Duane Arnold Energy Center

Response To Request For Additional Information Related To Request For Relief
Concerning Flow Measurement For the Standby Liquid Control Pumps

Response To Request For Additional Information Related To Request For Relief Concerning Flow Measurement For The Standby Liquid Control Pumps

BECHTEL SAN FRANCISCO		
IOWA ELECTRIC POWER & LIGHT DUANE ARNOLD ENERGY PLANT		
REACTOR BLDG. - AREA #1 STANDBY LIQUID CONTROL PUMP DISCHARGE TO VESSEL		
JOB No.	DRAWING No.	REV.
7884-	FSK-03959	9

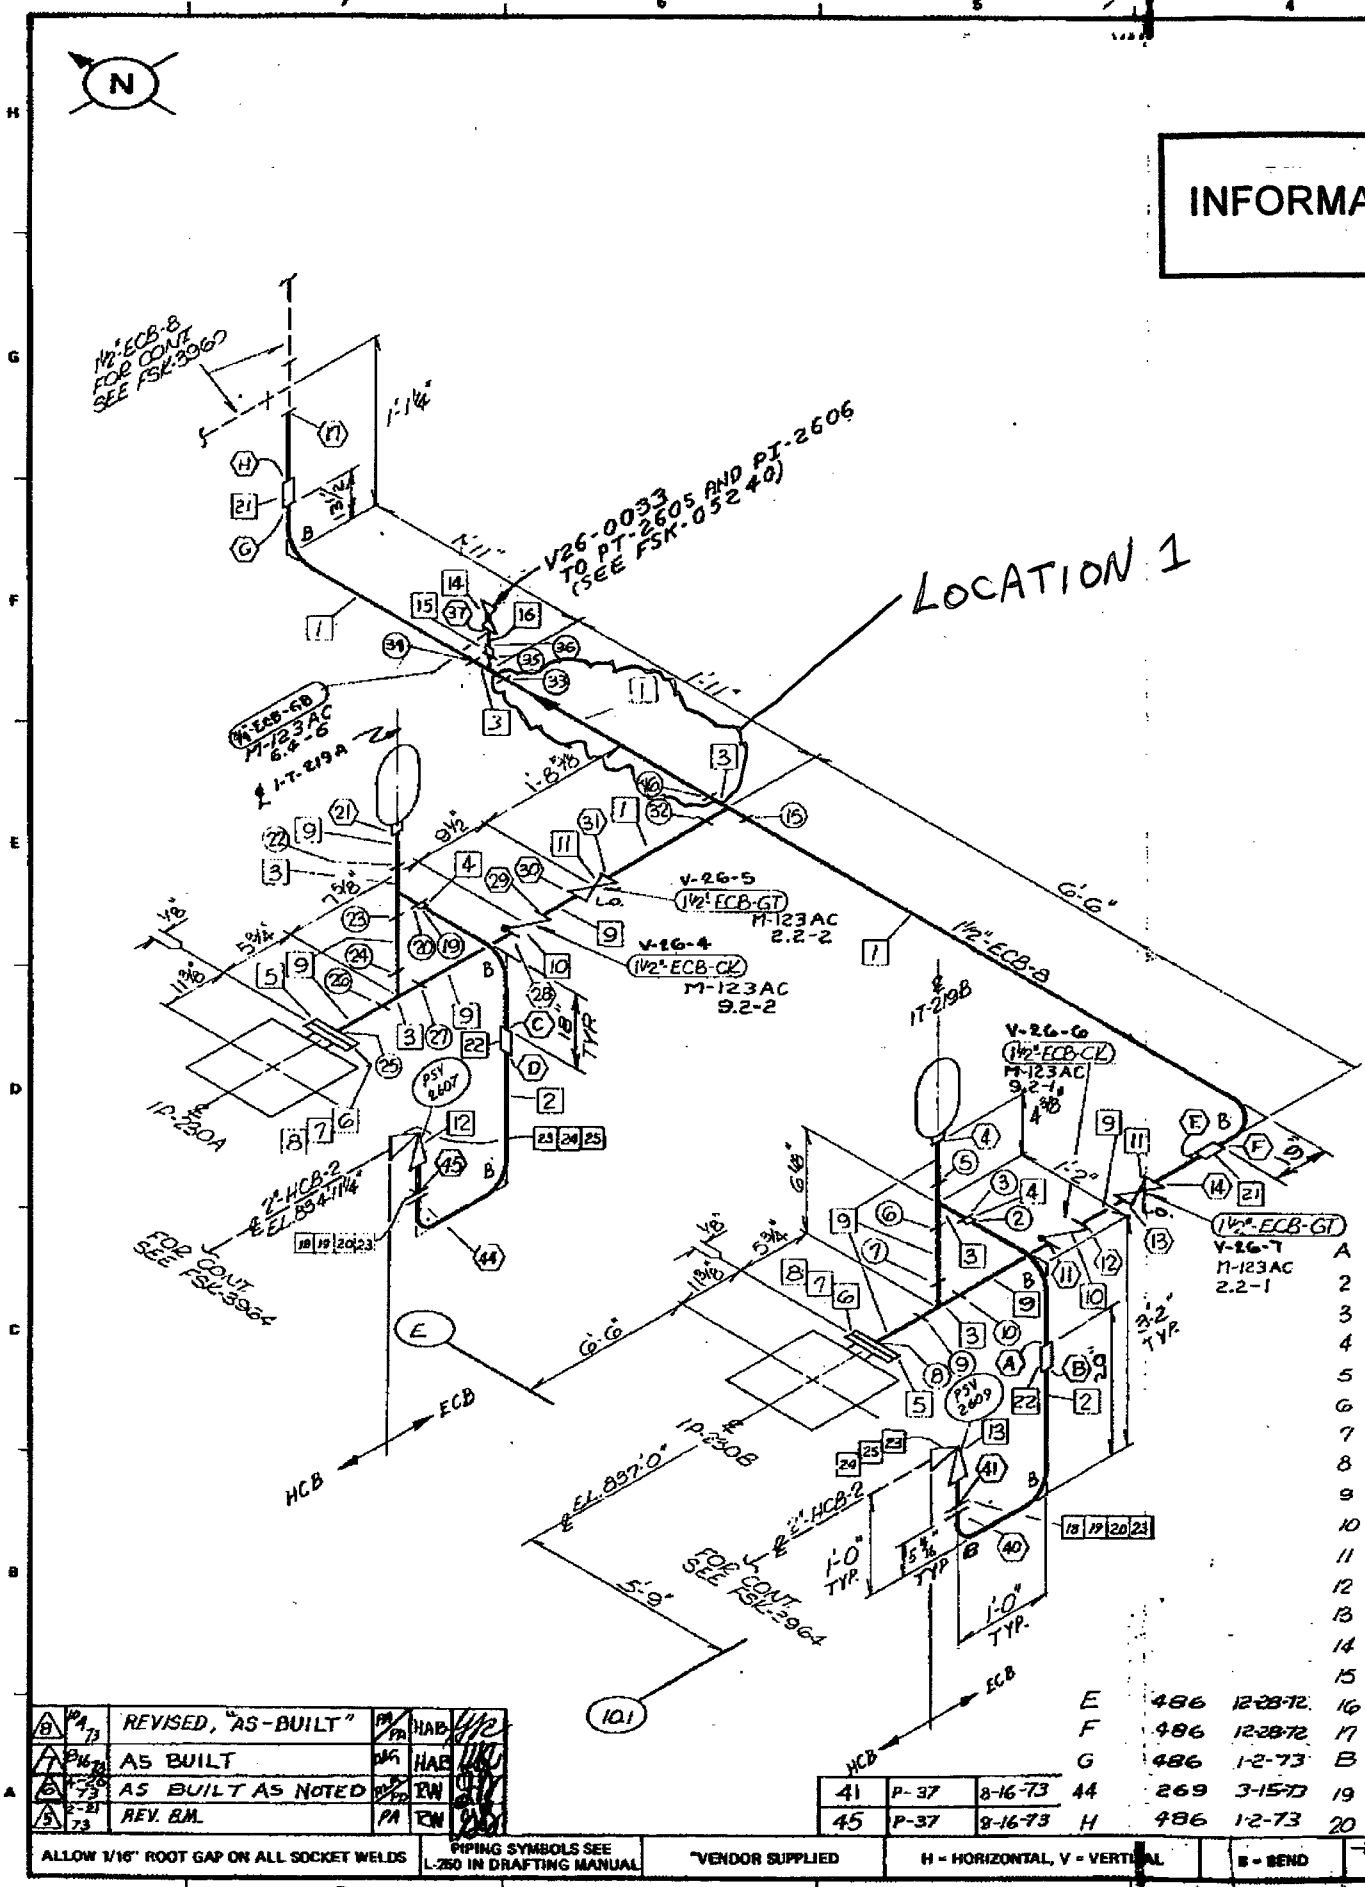
Please provide isometric diagram of the Standby Liquid Control (SBLC) System including details such as the length of piping and system components.

The licensee stated that portable ultrasonic flow meters were installed on the common SBLC pump discharge piping to determine the practicality of using later technology ultrasonic flow meters to measure flow. The flow meter transducers were installed at three different locations on the discharge piping. However, each location resulted in significantly different measured flow rates compared to the other locations and the test tank level method. Please provide the data on the measured flow rates at different locations using the ultrasonic flow meters and compare them to those using the test tank level method.

In March 2006, during the performance of Surveillance Test Procedure (STP) "SBLC Pump Operability Test," portable ultrasonic flow meters were installed on the SBLC pump discharge piping to determine the practicality of using ultrasonic flow meters to measure flow per the ASME OM Code. The flowmeter transducers were installed at three different locations on the discharge piping (as identified on the Attachment 1 drawings FSK-03959, FSK-3963, and FSK-3960). A vendor representative was on-site to facilitate proper installation and setup of the

transducers and flow meters. The pump flow rate calculated using the change in tank level method of the STP was 28.7 gpm for the "A" SBLC pump. The reference value for the "A" pump is 28.8 gpm. The flow rate from each subsequent test is compared to this value. Because of the simplicity of this test method, 28.7 gpm is considered the correct baseline value. Following are the results of flow measurement at each of the locations using the portable ultrasonic flow meters.

The transducers at location 1 were originally set up in direct measurement mode. (In direct measurement mode the transducers are placed on opposite sides of the pipe and a signal is passed through the pipe and fluid from one transducer to the other in both directions.) This mode, which was recommended by the manufacturer, did not provide adequate signal strength. The flow meter was then reprogrammed and the transducers were reconfigured for reflective mode. (In reflective mode both transducers are installed on the same side of the pipe and the signal from each transducer is reflected off the opposite side of the pipe and into the other transducer.) This mode indicated adequate signal strength. Initial flow rate in this configuration was steady at 28.2 to 28.5 gpm. After several minutes running in this configuration the vendor representative added additional UT couplant to the transducer that had been moved earlier. Flow rate increased to 30 gpm following addition of couplant. The vendor representative then programmed into the flow meter the "T" in the flow path just upstream of the transducer. Resulting flow rate was about 31.2 gpm. No more changes were made to this flow meter.

The transducers for the flow meter mounted at location 2 were mounted and programmed for direct measurement. Following pump start, this flow meter read erratically between 20 and 26 gpm and occasionally indicated a faulted condition. It was judged that due to the location (only a few feet from where flow enters the test tank and on the same elevation and down stream of the throttle valve) there may be air in the pipe which caused the erratic flow rates and faults. The transducers were then moved to Location 3.

At location 3, the transducers were mounted for measurement in the reflective mode. Flow measured in this configuration was 27.5 gpm. In the judgement of the vendor representative, the lower flow rate was the result of the elbow just downstream of the transducers.

As can be seen from the flow variances between the location and the tank level method, the measured flow variance is much higher than would be desirable or acceptable. The flow variance is caused by the tight piping routing and minimal straight runs of piping.
